DELEGATED DECISIONS BY CABINET MEMBER FOR TRANSPORT

OXFORD: A4158 ROSE HILL – OPTIONS FOR SAFETY IMPROVEMENTS AT THE SERVICE ROAD JUNCTIONS

Report by Director of Environment and Highways

Recent collision history

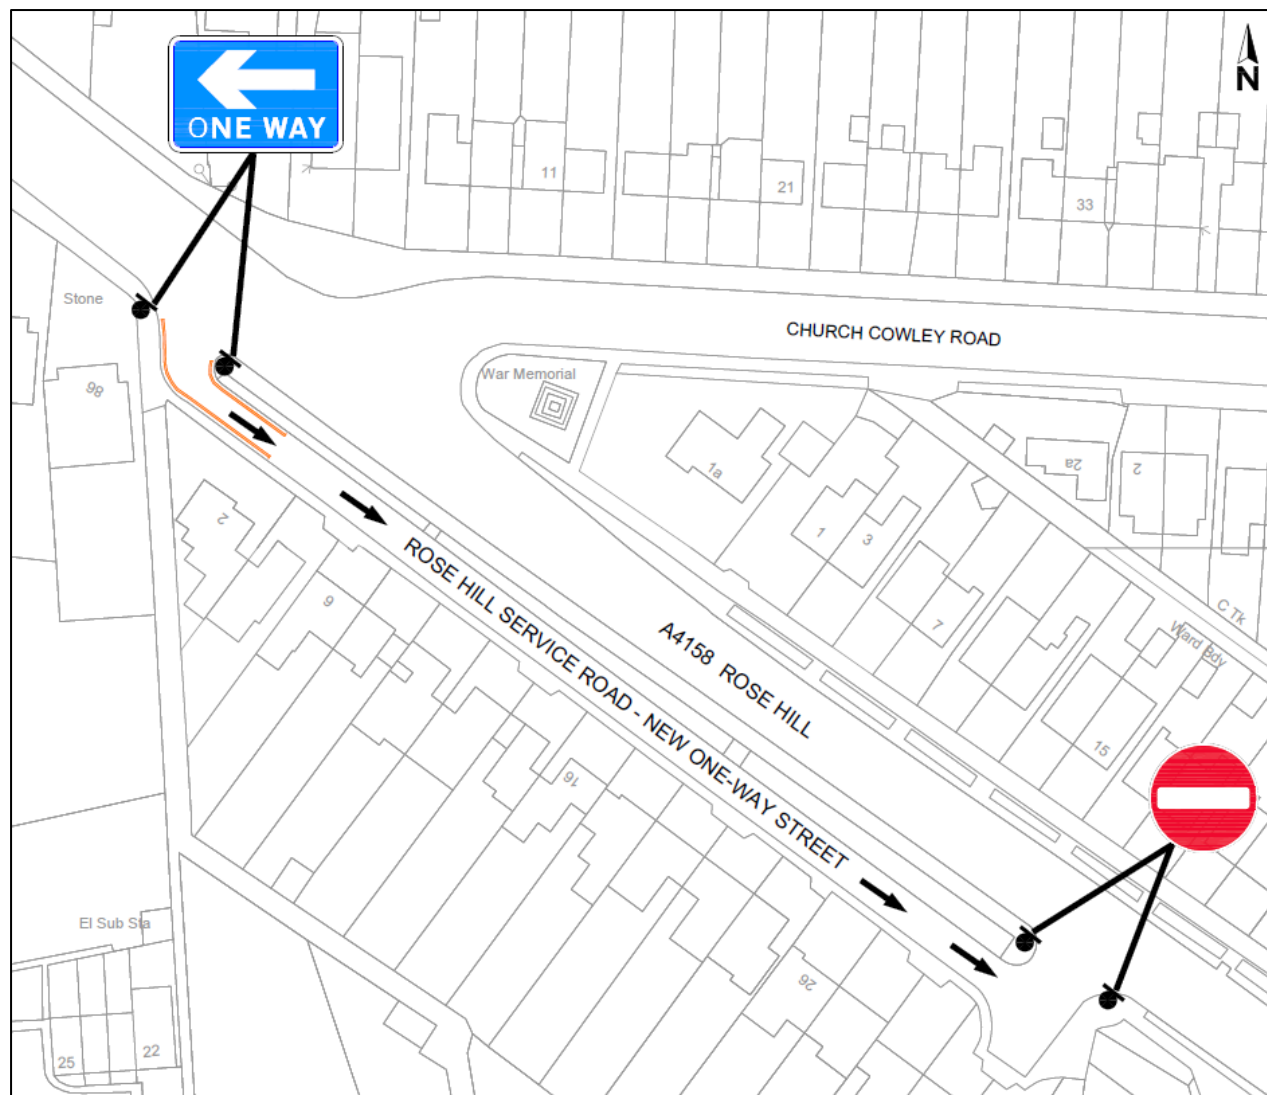
8. The collision pattern – as shown in **Annex 1** – at the south-eastern junction is a relatively recent phenomenon, with seven injury collisions (two serious, five slight) occurring over the last three years. All seven are similar, involving a north-westbound vehicle turning into the service road and colliding with a pedal cycle in the advisory cycle lane, travelling in the same direction.

Option 1 – one-way street

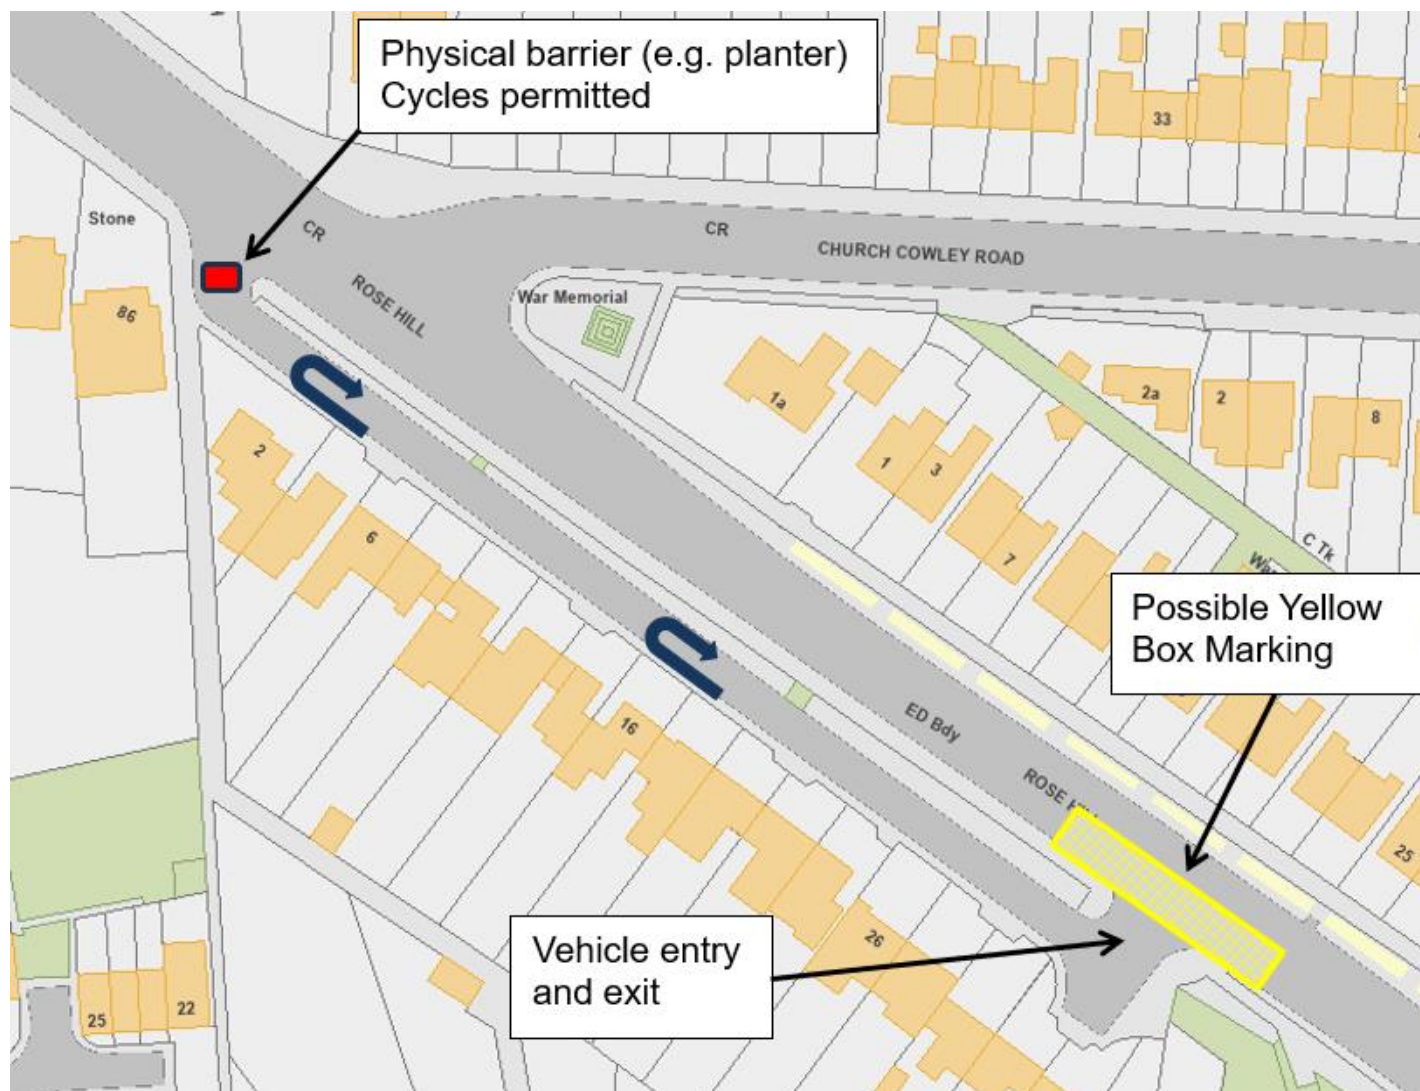
32. The one-way street option is shown in **Annex 2**. Vehicles would only be allowed to access the service road via the northern access (**Annex 11**), where additional double yellow lines would prevent vehicles from parking, therefore maintaining a clear area to allow larger vehicles to be able to turn in. This has been verified using swept path (tracking) analysis, and the City Council have confirmed that refuse collection vehicles would be able to manoeuvre in.
33. Exit from the service road would be via the southern access (**Annex 12**) only, where a Yellow Box Marking could be installed to assist vehicles when turning out to the right.

34. This option would be relatively cheap to implement as it does not require any physical alterations or camera enforcement. It will have simple and clear signage at each end, although the restriction could be ignored but this is considered unlikely. An exemption can be made for cyclists, so that they can continue northwards along the service road in contraflow to vehicles.

35. Preventing the left turn into the southern access will eliminate the manoeuvre which has led to the cyclist casualties.
36. At present, residents approaching from the north appear to use the southern access to turn right in, as evidenced by the direction of parked cars. This one-way option would mean that drivers will have to turn right into the northern access, which is awkward because of the hatched central markings and absence of a filter lane.

37. The restriction would also mean that any residents or visitors who are approaching from the south along Rose Hill or along Church Cowley Road will be obliged to use the northern access to turn left into the service road. A site check has been performed on this movement several times in a long car and, although it is effectively a sharp 180-degree turn, it was achievable, even with a parked car present.

38. As the advisory cycle lane continues past the northern access, increasing the number of vehicle movements here will increase the likelihood of "left hook" collisions, although it will be very much less than at the southern access at present. There is considerable uncertainty about the safety of this manoeuvre being carried out by larger vehicles.

Option 2 – prohibition of motor vehicles by physical barrier at northern end

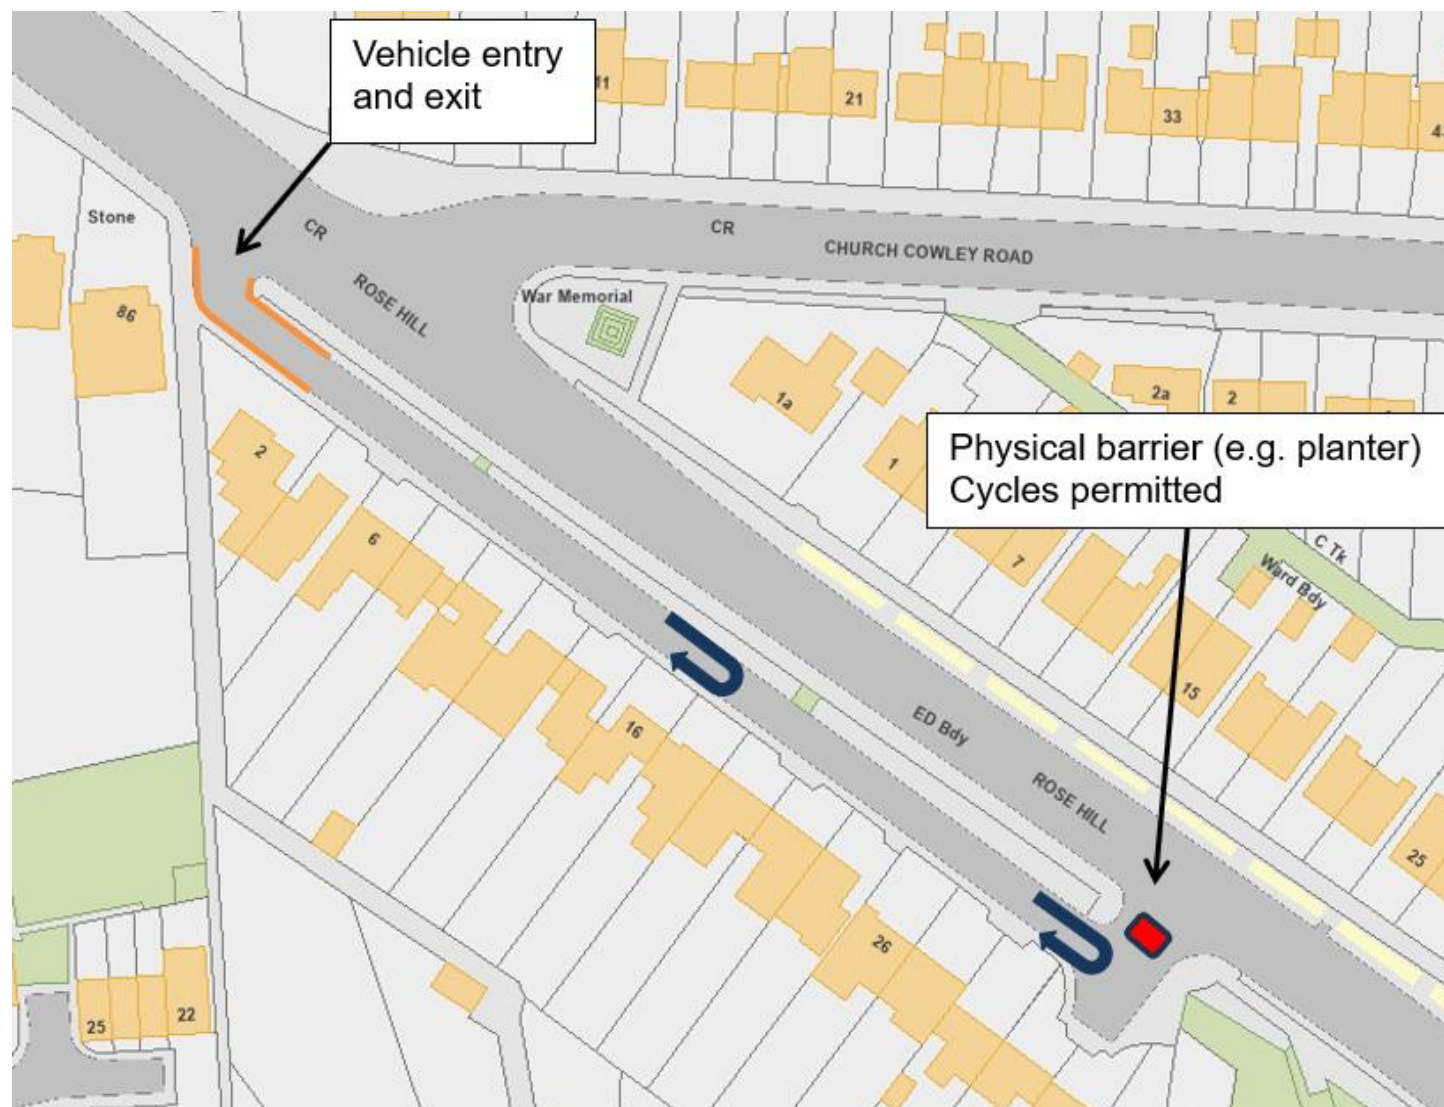
41. This option is as illustrated in **Annex 3**. Entry to, and exit from, the service road would be via the southern access, where a Yellow Box Marking could be installed.
42. The number of vehicles turning left into the southern access will be greatly reduced as it will be limited to service road residents and visitors only, but the manoeuvre will not be completely eliminated.
43. All vehicles that enter the service road will have to make a 180-degree turn so that they can also leave by the southern access. For some residents the turn

can be made in an off-road parking space, but all other vehicles (including visitors to the dental surgery at the north end) will have to turn in the carriageway. This will be awkward given the absence of a formal turning area and the relatively narrow kerb-to-kerb width (approximately 5.0m). Vehicles turning in the carriageway will nearly always overhang the footway when reversing, creating a minor safety hazard.

44. Larger vehicles (e.g. delivery vans) may choose to reverse back to the southern turning area rather than perform a multi-point turn in the carriageway. It should be noted that this “hammerhead” appears to have been constructed to create space for the two driveways coming off to the south-east. It does not, therefore, have the typical dimensions of a turning head, which would have a straight extension of about 3.5m to accommodate the largest vehicles (see **Annex 13**). Furthermore, parked vehicles may further reduce the space available for turning.

45. This option would be relatively cheap to implement and maintain. It would also benefit pedestrians as they would be able to walk across the northern access unhindered by turning vehicles.

46. The physical barrier will prevent vehicles from making the awkward turns into and out of the northern access; however, this removes the option for residents as exemptions cannot apply.

Of the other options, any options that add a physical barrier (Option 2/3) would seem like a non-starter. I don't think there is enough turning circle at either end of the street, and asking people to reverse down a narrow street with parked cars is asking for trouble.

Option 3 – prohibition of motor vehicles by physical barrier at southern end

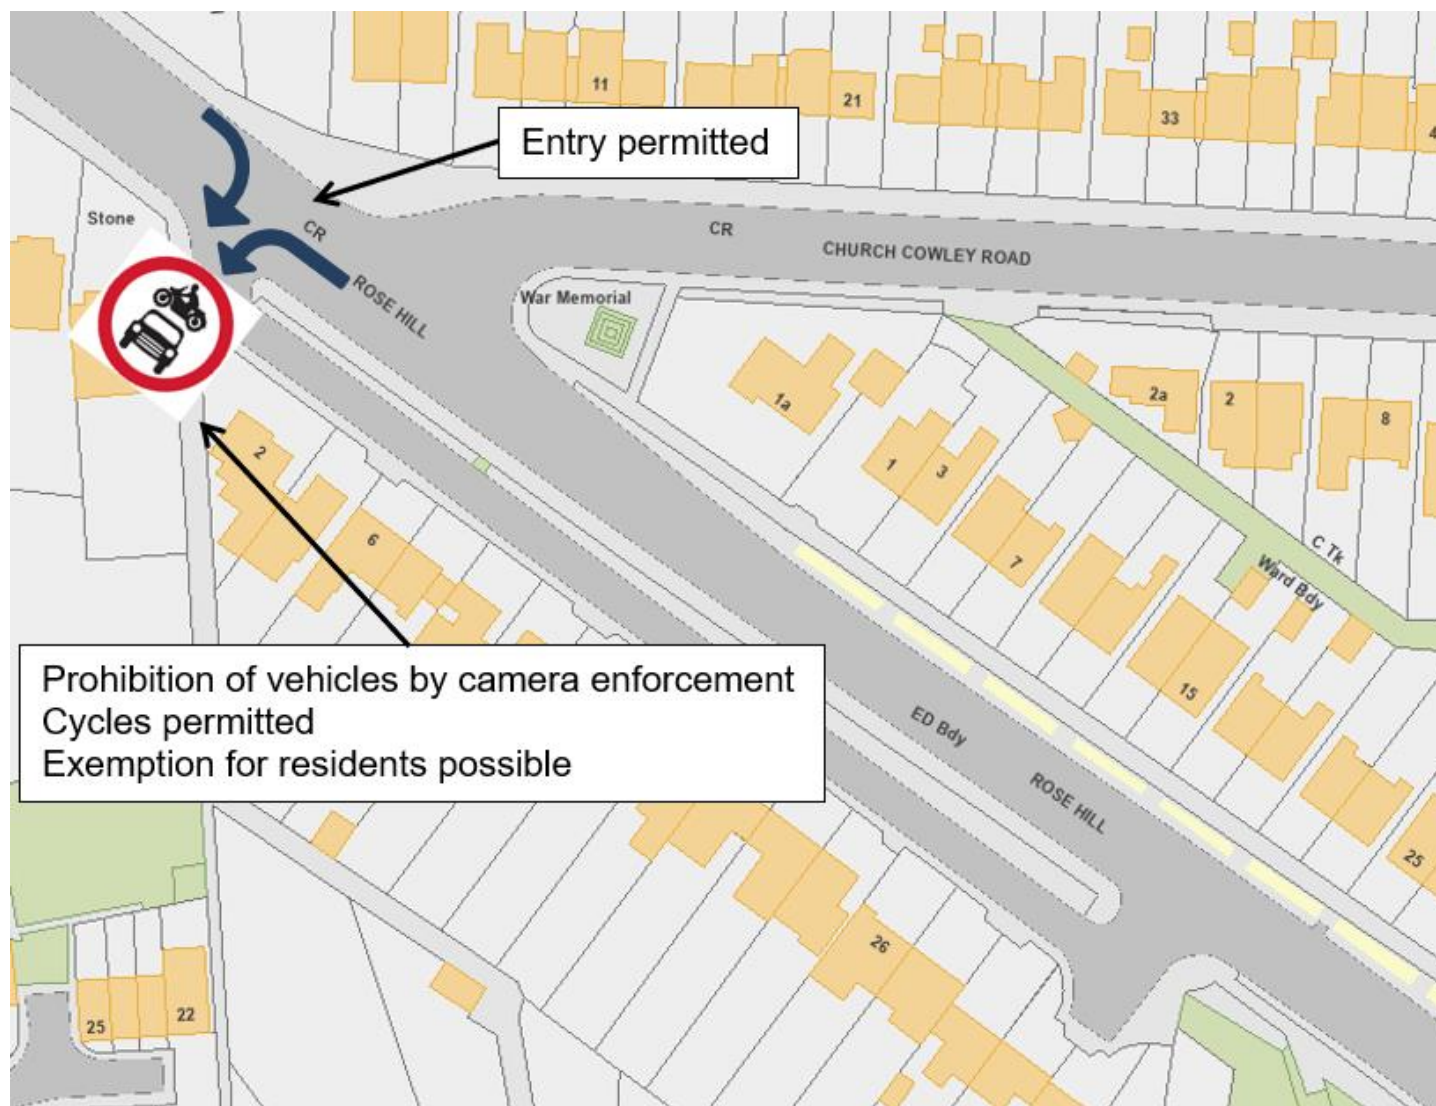
47. This option is as illustrated in **Annex 4**. Entry to, and exit from, the service road would be via the northern access.
48. Preventing the left turn by vehicles into the southern access will eliminate the manoeuvre which has led to the cyclist casualties.

49. All vehicles that enter the service road will have to make a 180-degree turn so that they can also leave by the northern access. For some residents the turn can be made in an off-road parking space, but all other vehicles (including visitors to the dental surgery at the north end) will have to turn in the carriageway or in the turning area at the southern end.

50. As noted above, the turning area does not have the dimensions of a typical “hammerhead” turning space found in a residential development. Furthermore, the physical measures (i.e. planters and/or bollards) that are used at the opening will reduce the turning space available, so it may not be suitable for larger vehicles.

51. The physical measures may also present a hazard to cyclists who may turn left into the service road at a relatively high speed from the downhill section of Rose Hill.

52. Any driver wishing to leave the service road and head south on Rose Hill will have to turn right from the northern exit. This is a particularly difficult manoeuvre

given the proximity of the traffic signals and islands, high number of pedestrian movements, the Advanced Stop Line for cyclists in the far lane and the flows/queueing of traffic depending on the cycle of the signals.

My preference would be for hard infrastructure at the Southern end, i.e Option 3 - for the reasons laid out by Cyclox. This is also cheaper to maintain and likely to have more of an impact than ANPR - we are talking about approximately 20 residents on the road, not all of whom have cars, so spending tens of thousands of pounds on ANPR seems illogical. And we know that a lot of people ignore / don't see ANPR cameras so they're significantly less effective. But if we do have ANPR, it should be ANPR without resident exemptions. I am particularly concerned about the mooted idea of "ANPR with resident exemptions". First, this is absolutely not policy compliant. To my knowledge, we do not have a policy which says "make it easier for people to use private cars if they happen to live nearby". Our LTCP transport hierarchy is extremely clear. Local resident private cars are not prioritised over other private cars. Indeed, we have two policies which apply here (Vision Zero, LTCP) and ANPR would go against both of those. Second, it's setting an extremely dangerous precedent for our other ANPR filters, and the wider implications need to be considered. I'm constantly asked why residents can't have exemptions, and the reason for that is because it would ruin the integrity of our low traffic schemes, turning them into "medium traffic schemes". I am aware there may need to be some exemptions, e.g. for school streets when there is no possible alternative. In this case, however, residents have a very easy alternative - they can just do what everyone else is supposed to do. Endangering the schemes which thousands of people benefit from (i.e. the LTNs) just so fewer than 20 residents (many of whom won't drive private cars) can avoid driving 50m further seems to be an idea with extremely limited upside and extremely significant downside. So in conclusion, I think in order to stick to our own policies it's most sensible to use an ETRO to block the service road at the Southern Entrance, and to monitor that during the 18 month period. If we have an endless stream of 6t luton lorries which need to turn around there and struggle to do so, it can be re-thought. Regardless if ANPR is chosen it should ABSOLUTELY NOT include resident exemptions or else we are going against policy and undermining the entire County's transport strategy.

Option 4 – prohibition of vehicles by camera enforcement at northern end

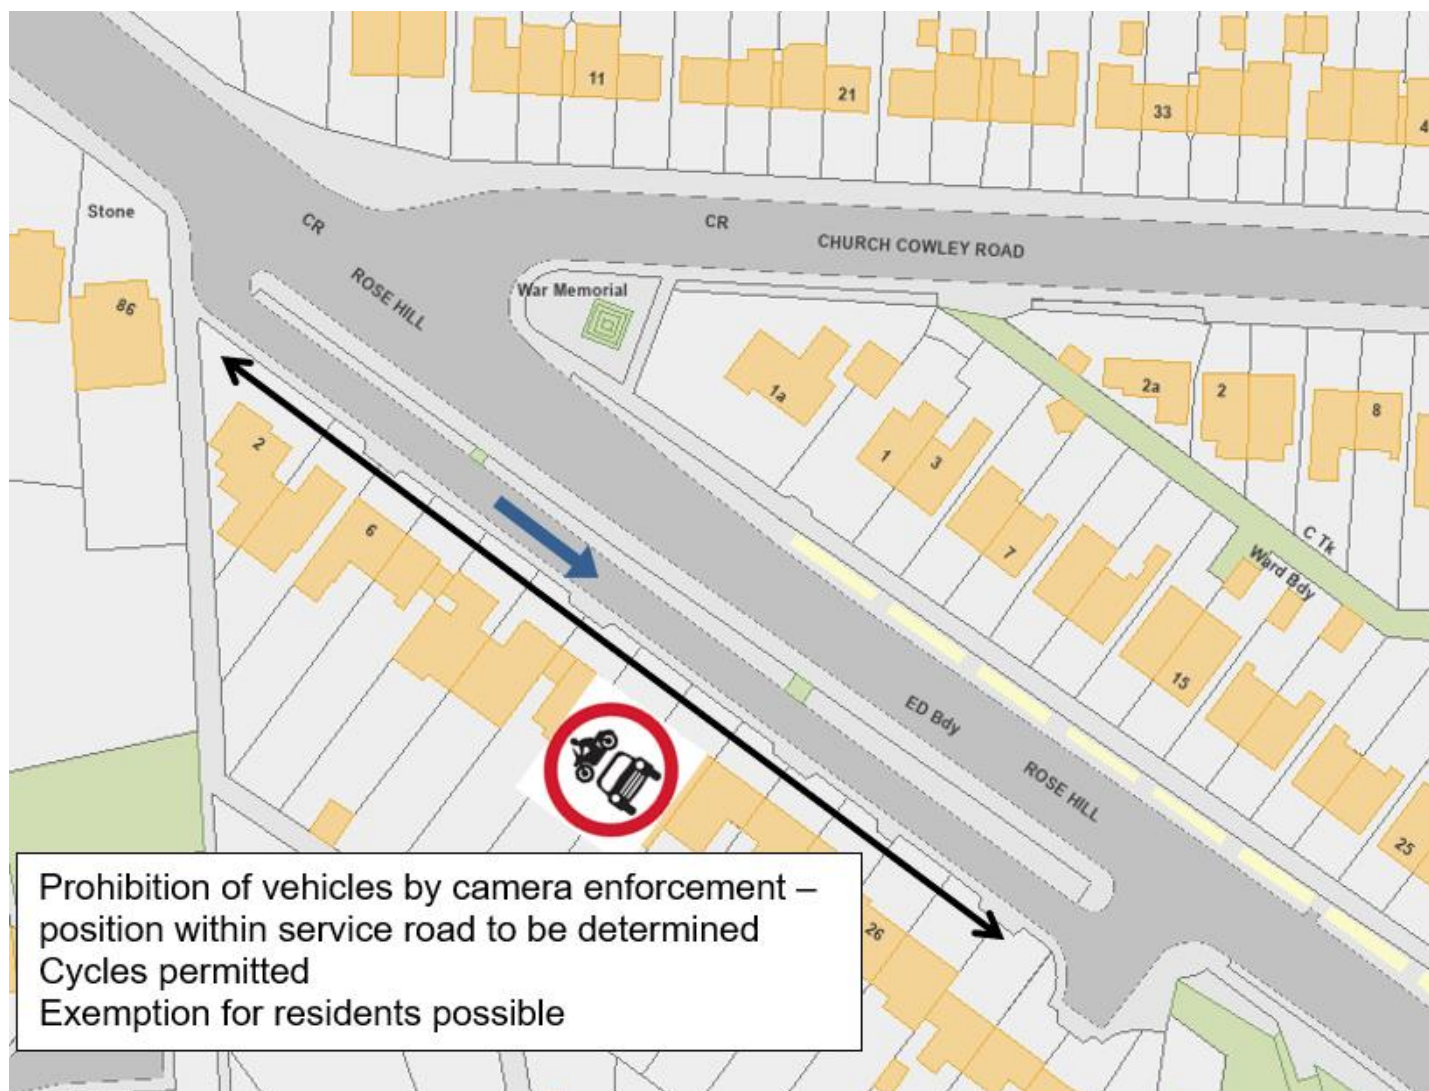
- 60. This option is as illustrated in **Annex 5**. Entry to the service road for all vehicles is by either access, while non-exempt vehicles are prohibited from exiting via the northern end.
- 61. It may be difficult to provide effective signage in advance of the southern turn into the service road, with the restriction being at the far end. Therefore, drivers may enter the service road in error and be obliged to make the difficult 180-degree turn as described in (ii) above.

Option 4 would be ok for residents, who can typically turn in their own driveway, but I imagine that for larger vehicles it would be a challenge to expect to U-turn outside the dental practice.
